# Agenda for 74<sup>th</sup> PCCM

Govt. of India  
Ministry of Power  
North Eastern Regional Power Committee  
Shillong

**74<sup>th</sup> Protection Coordination Sub-Committee Meeting**

**Date:** 16/12/2024 (Monday)

#### **B.7 Grid Disturbance in Lumshnong area of Meghalaya on 15-11-2024:**

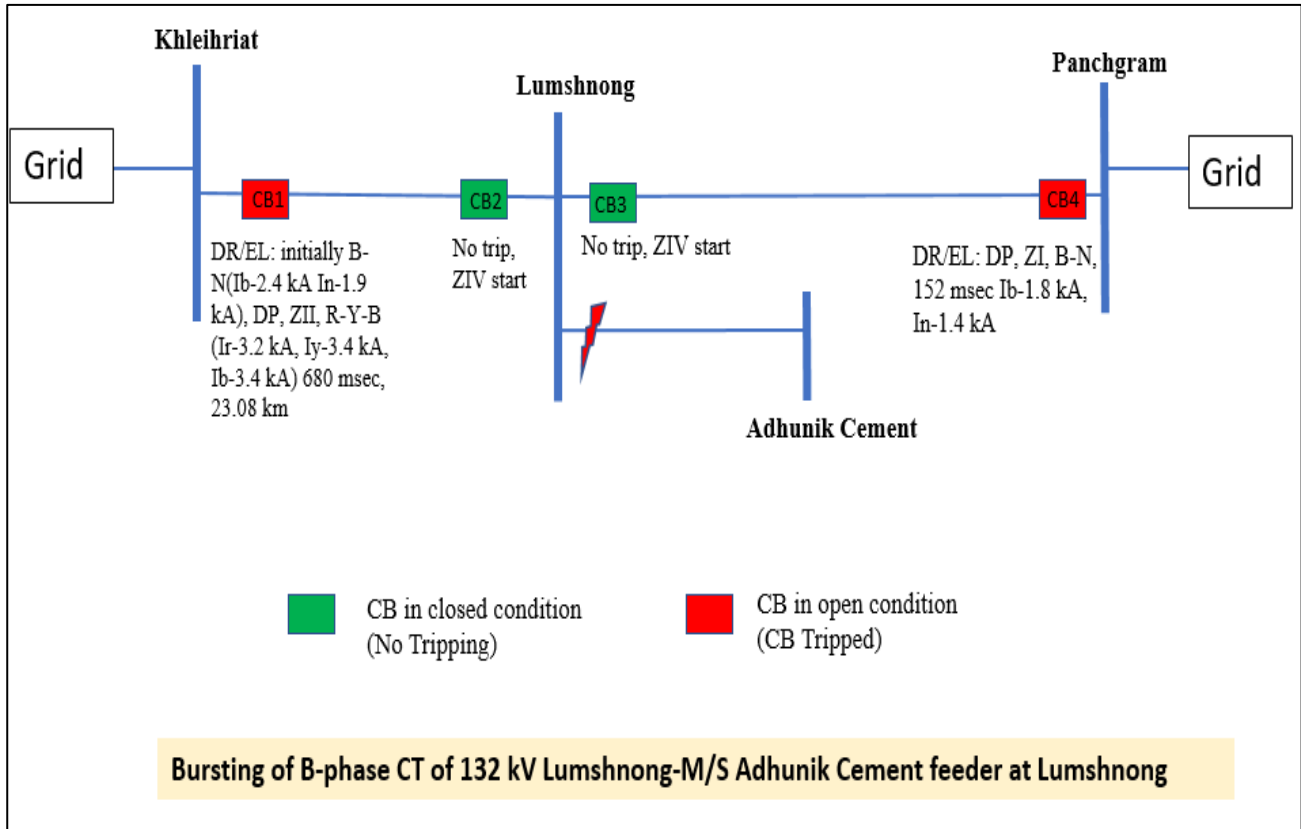
- For 132 kV Lumshnong-Panchgram line, B-N fault initiated at 22:13:34.511 Hrs and cleared within 152 msec on ZI from Panchgram end. There was no tripping from Lumshnong end (ZIV pickup)

- For 132 kV Khleihriat-Lumshnong line, B-N fault initiated and after 186 msec, fault current disappeared. Again after 86 msec, B-N fault reappeared and first converted into Y-B-N fault and then into R-Y-B fault which was cleared within 680 msec on operation of DP, ZII. There was no tripping from Lumshnong end (ZIV pickup)

- Fault was in 132 kV Lumshnong-M/S Adhunik Cement feeder due to bursting of B-ph CT at Lumshnong which was not cleared from Lumshnong end causing tripping of healthy 132 kV Khleihriat-Lumshnong line & 132 kV Lumshnong-Panchgram line.

- Tripping of 132 kV Panchgram-Lumshnong line on ZI from Panchgram end seems to have overreached. AEGCL needs to check/review the distance setting to avoid overreaching of ZI.

- Time drift of 1 Hour observed at Khleihriat end for 132 kV Khleihriat-Lumshnong line which need to be sync with GPS by MePTCL.

- Share the root cause and remedial measures taken.
- Furnish the reason of non-operation of protection system at Lumshnong end for 132 kV Lumshnong-M/S Adhunik Cement feeder.
- Check/review the distance protection setting to avoid overreaching of ZI.
- Rectify the DR time drift at Khleihriat end.

### **B.9 Grid disturbance in Umrangsho area of Assam on 24-11-2024:**

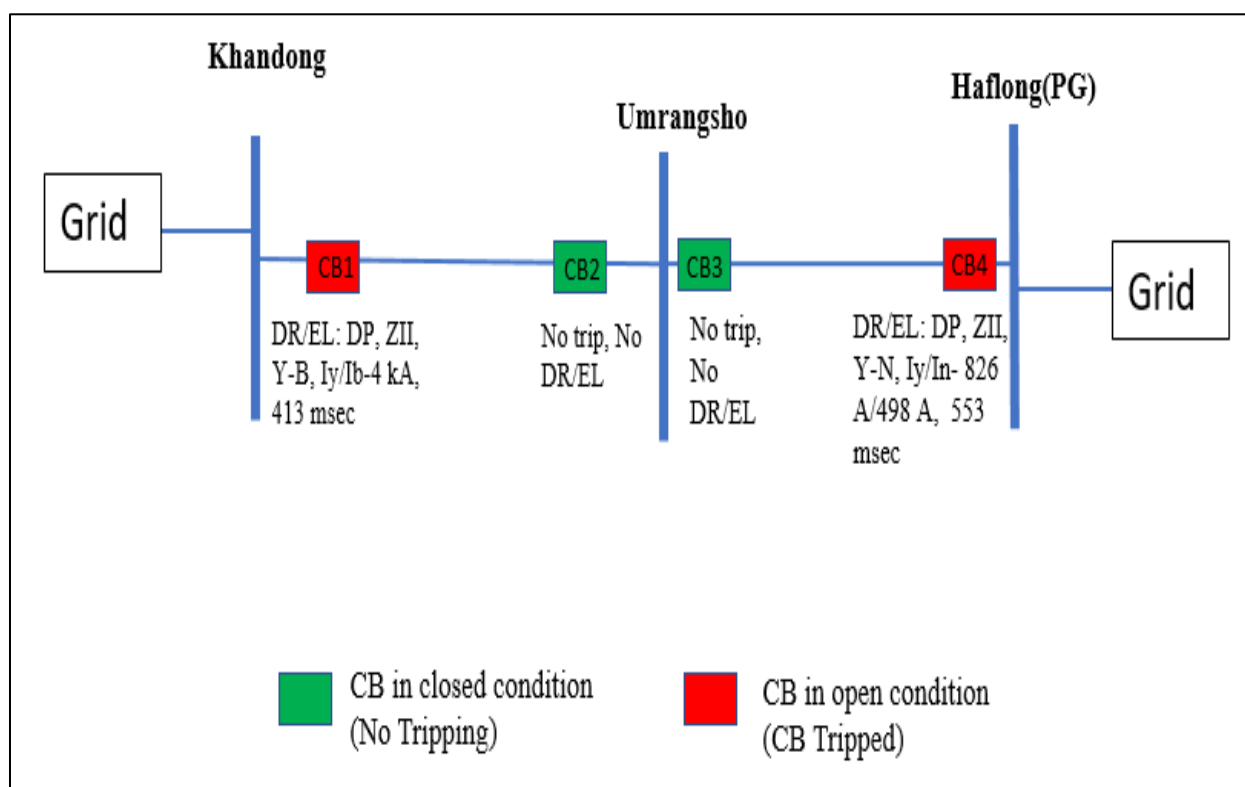
As per DR analysis of 132 kV Khandong-Umrangsho line, Y-B fault (Iy-4 kA, Ib-4 kA) initiated at 04:55:26.146 Hrs and cleared within 413 msec on operation of DP, ZII from Khandong end. There was no tripping from Umrangsho end.

As per DR analysis of 132 kV Haflong(PG)-Umrangsho line, Y-N fault (Iy-826 A In-498 A) initiated at 04:55:24.959 Hrs and cleared within 553 msec from Haflong(PG) end on operation of DP, ZII. There was no tripping from Umrangsho end.

**As informed by AEGCL, fault was in between CVT, LA and Gantry point of 132kV Umrangshu – Haflong (PG) line.**

- Update the reason of non-tripping of Umrangsho CB for 132 kV Haflong(PG)-Umrangsho line.
- Submit DR/EL at Umrangsho end for both the lines for proper analysis of the event.

**B.10 Grid Disturbance in Monarchak and Rokhia areas of Tripura on 06-12-2024:**

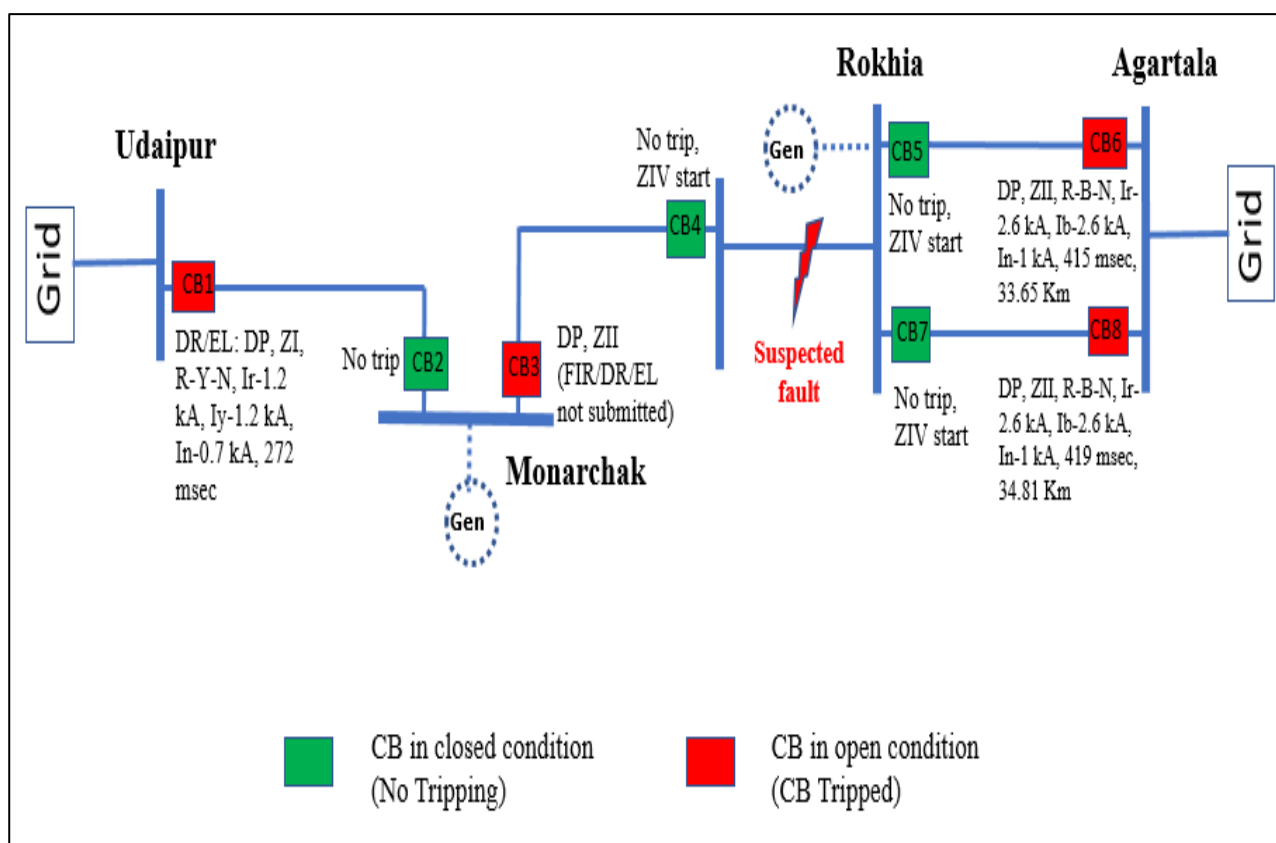
As per DR analysis, R-B-N fault initiated at 13:05:19.698 Hrs and cleared within 415 msec from Agartala end on operation of DP, ZII. No tripping from Rokhia end (ZIV start)

132 kV Monarchak-Rokhia line tripped on ZII from Monarchak (No FIR/DR/EL submitted). There was no tripping from Rokhia end (ZIV start)

- Suspected fault in 132 kV Rokhia-Rokhia link feeder which was not cleared leading to tripping of healthy lines 132 kV Monarchak-Rokhia line & 132 kV Agartala-Rokhia D/C lines on ZII from remote ends.
- At the same time, 132 kV Monarchak-Udaipur line tripped on ZI from Udaipur end which seems unwanted.
- At the same time, AGTCCPP Unit-2 & 6 tripped which seems to be misoperation.

- Share the root cause and remedial actions taken.
- Update the status of installation of Line differential protection in 132 kV Rokhia-Rokhia Link feeder.
- Furnish the reason of tripping of 132 kV Monarchak-Udaipur line for fault in 132 kV Rokhia S/S.
- Reason of tripping of AGTCCPP Unit-2 & 6.
- Submit detailed report in compliance with IEGC-23
- Submit DR/EL within the specified timeline as per IEGC-23.

### **C.3 Grid Disturbance in the Imphal (Yurembam) substation of Manipur power system on 28th October 2024:**

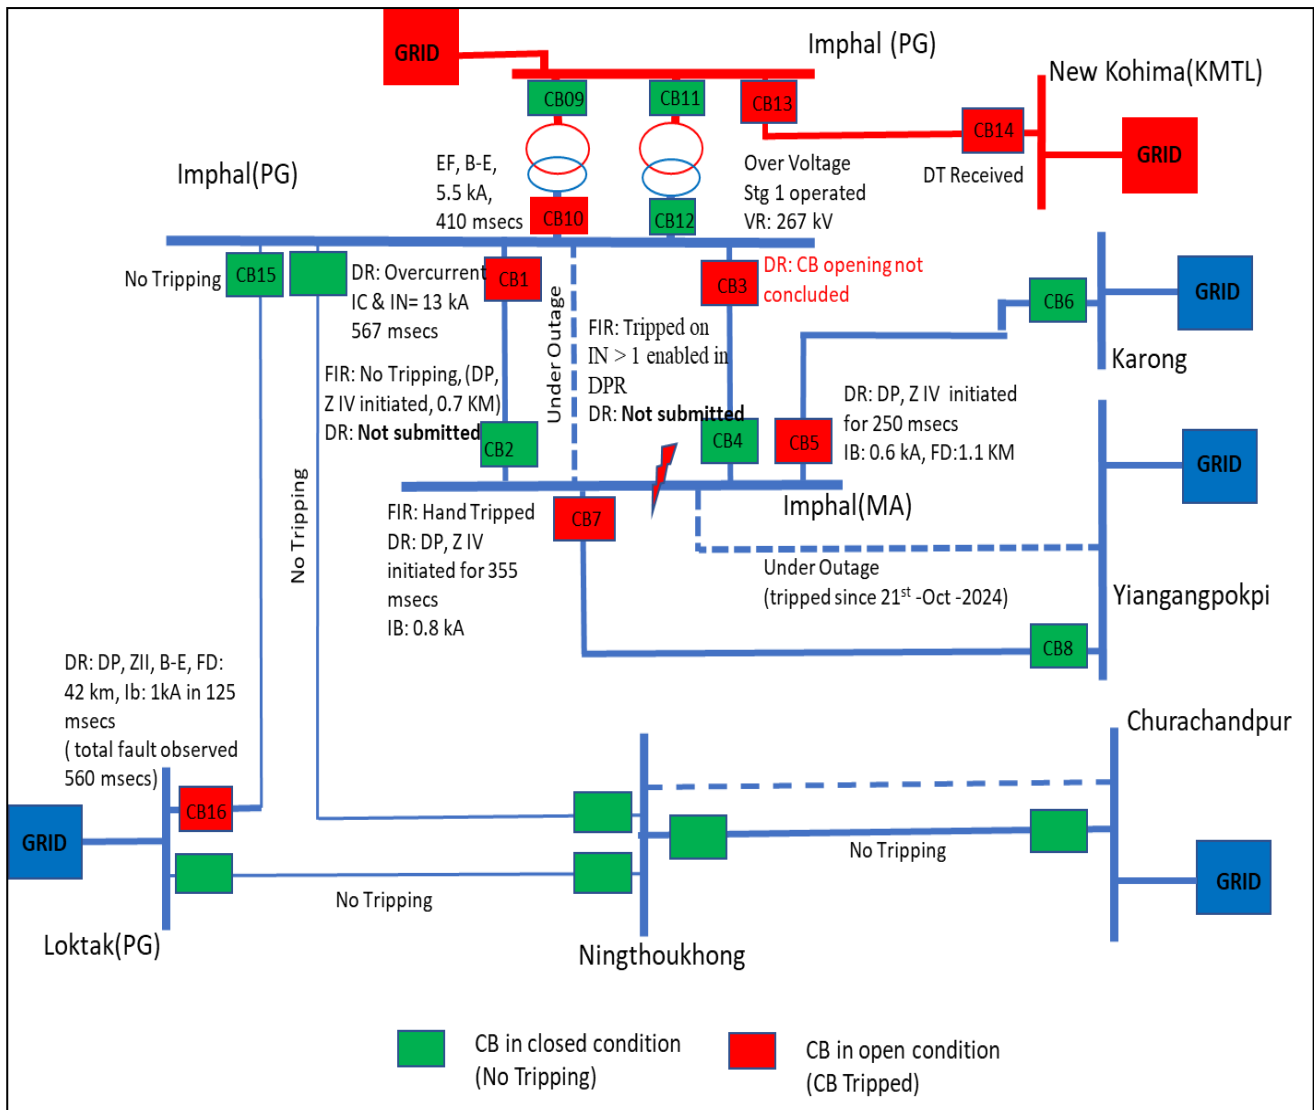
1. 132 kV Imphal(PG)- Imphal(Yurembam) 1 Line tripped on Overcurrent at Imphal(PG) end in 567 msec. However, the same was not detected by the Main Relay. To be checked by NERTS.

2. 315 MVA ICT I at Imphal(PG) tripped at 132 kV side on Backup E/F in 410 msec on reverse fault. Directionality of the LV side backup relay need to be rectified by NERTS.

3. High Voltage of Vre: 267 kV observed in the Imphal(PG) end of the 400 kV Imphal(PG) - New Kohima 1 Line after the tripping of Tie CB of 315 MVA, ICT-1 which resulted into the tripping of the line. NERTS is requested to check & rectify the reason for HV in the R-Phase of 400 kV Imphal(PG) - New Kohima 1 Line.

4. 132 kV Imphal (PG) - Loktak Line detected the fault in ZIII for 420 msec & then ZII initiated and tripped the CB in next 125 msec. However, ZII time delay need to be reviewed by NHPC.

5. Tripping of 132 kV Imphal (Yurembam) - Yaingangpokpi 1 Line, 132 kV Imphal (MSPCL) - Karong Line and 132 kV Imphal(PG)- Imphal(Yurembam) 3 Lines could not be concluded due to non-availability of the DR & EL of Yaingangpokpi, Karong and Imphal (Yurembam) end. MSPCL is requested to share the DR & EL files.

6. DR time synch Issue observed in the submitted DR for CB3 and CB7. MSPCL is requested to rectify the same for proper analysis purpose.

1. Manipur stated, regarding the root cause of the fault, that fault initiated due to B-phase Bus jumper snapping at Yurembam SS, however further investigation are underway to ascertain the correct root cause of the fault.

2. NERTS informed that for 132 kV Imphal(PG)-Imphal(Yurembam) III line, Bay at Imphal(PG) owned by MSPCL and relay did not sense any fault during the event.

3. 132 kV Imphal(PG)- Imphal(Yurembam) 1 Line tripped on Overcurrent at Imphal(PG) end in 567 msecs. NERTS informed that distance relay sensed the fault in ZIII.

4. NERTS informed there was some wiring issue in 315 MVA ICT-I at Imphal which has been rectified.
5. NERTS informed O/V at Imphal(PG) was caused in 400 kV Imphal-New Kohima I line during switching of PT selection relays during trip of ICT-1 in which contact of PT selection relay was found burnt & continuously shorted. The same has been replaced.
